TOWN OF MOUNTAIN VILLAGE REGULAR DESIGN REVIEW BOARD MEETING AGENDA

THURSDAY NOVEMBER 5, 2020 10:00 AM MOUNTAIN VILLAGE TOWN HALL

6.	10:30	45	Miller Applicant	Quasi-Judicial	Consideration of a Design Review: Final Architecture Review for a new single-family residence on Lot 716, 167 Adams Ranch Road, pursuant to CDC Section 17.4.11.

7.	11:15	45	Miller Applicant	Quasi-Judicial	Consideration of a Design Review: Final Architecture Review for a Class 3 Residential Addition, Lot 424, 121 Touchdown Drive, pursuant to CDC Section 17.4.11. This item was continued from 10.01.2020.

Max Average Height Roof Plan

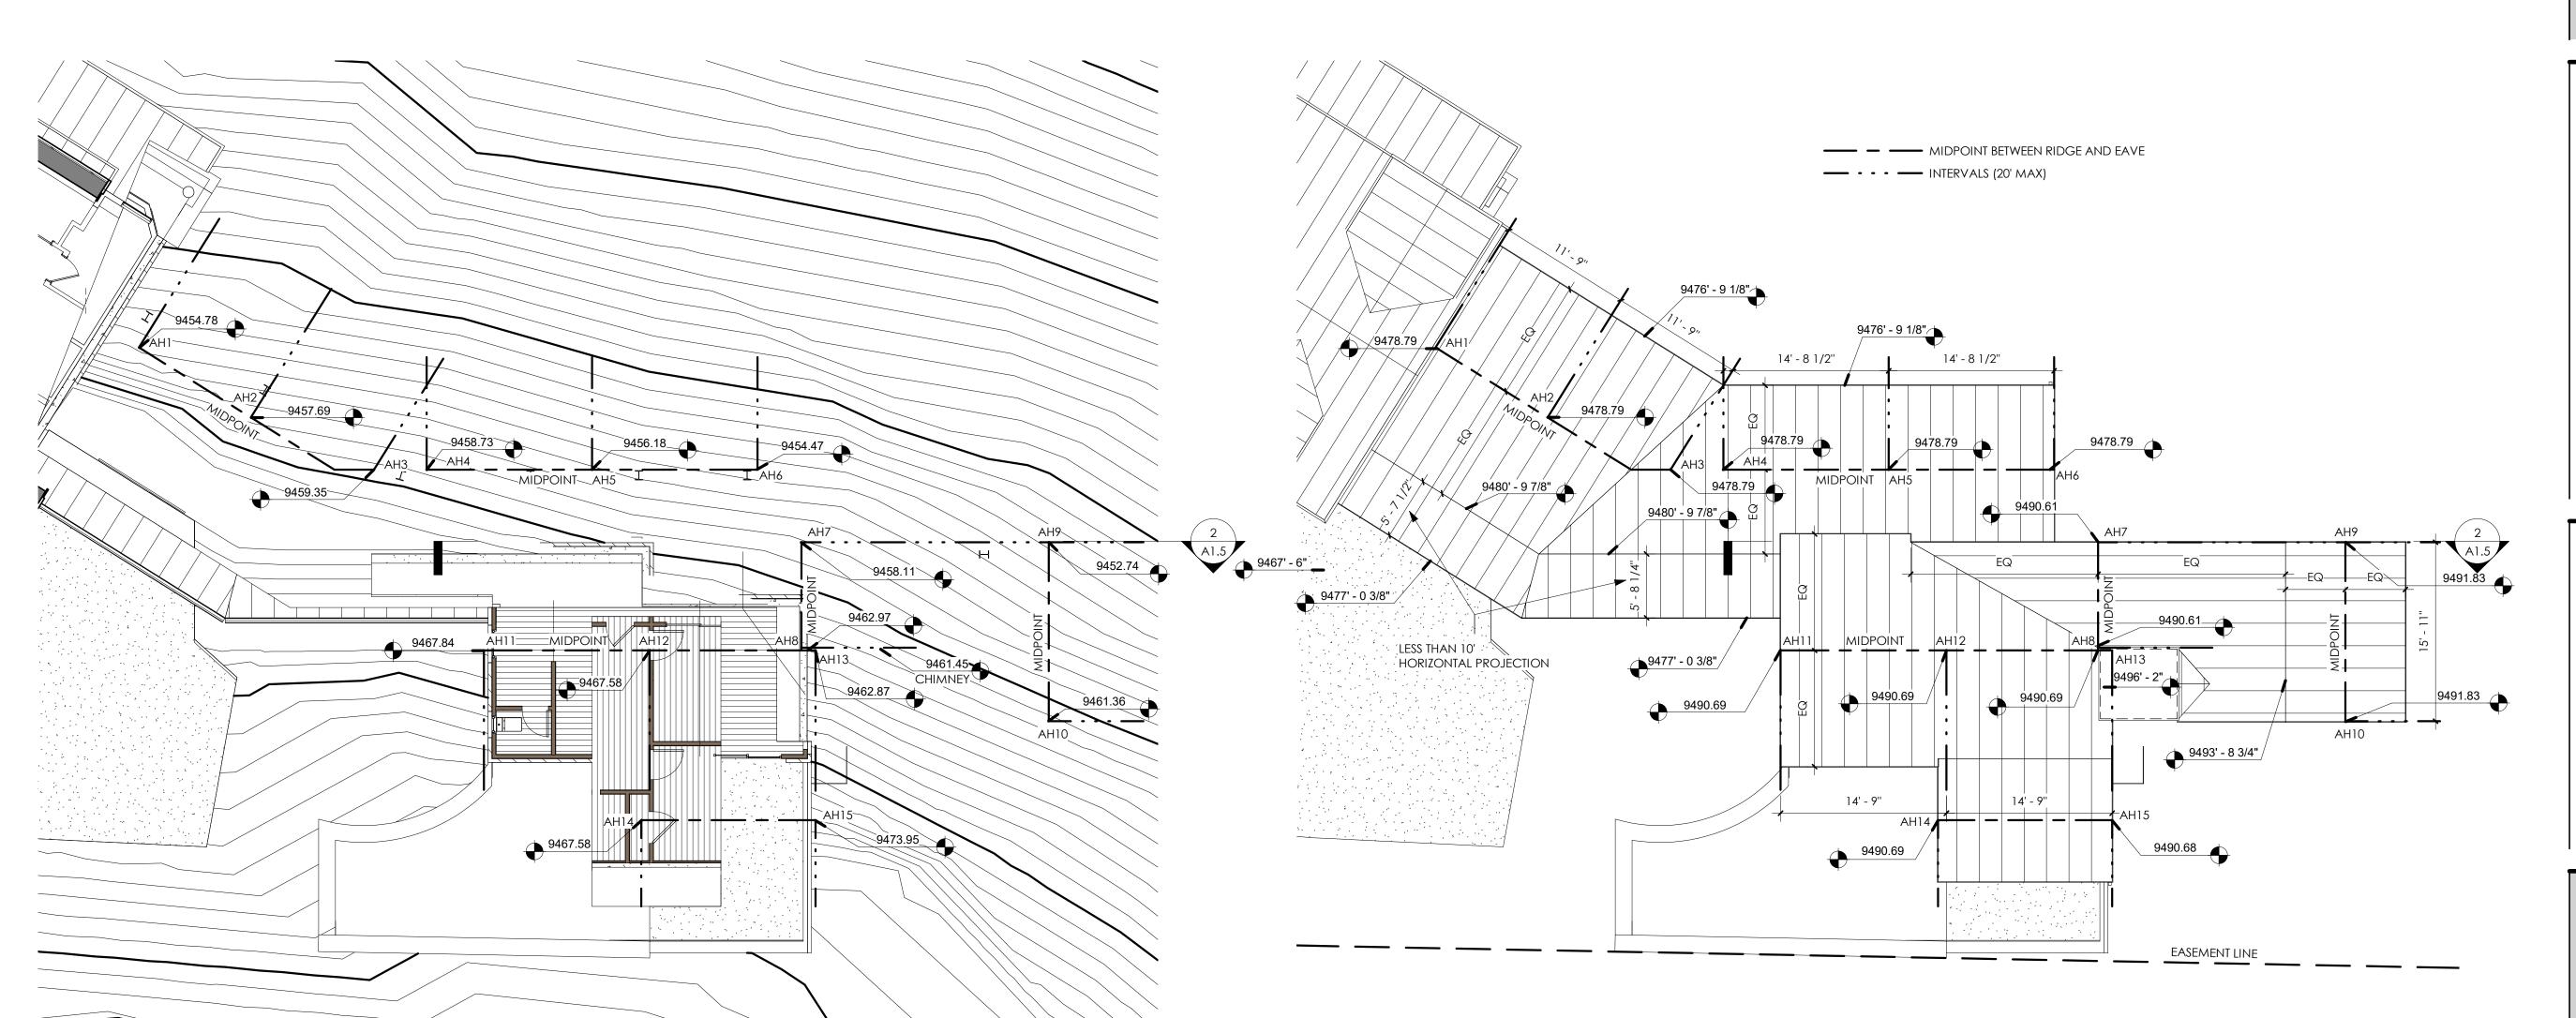
Staff: The applicant has provided a Building Height Analysis on submitted page A1.5 which demonstrates both Maximum Building Height and Maximum Average Building Height as being complaint with the CDC. In addition, they have provided a parallel plane analysis also demonstrating compliance.
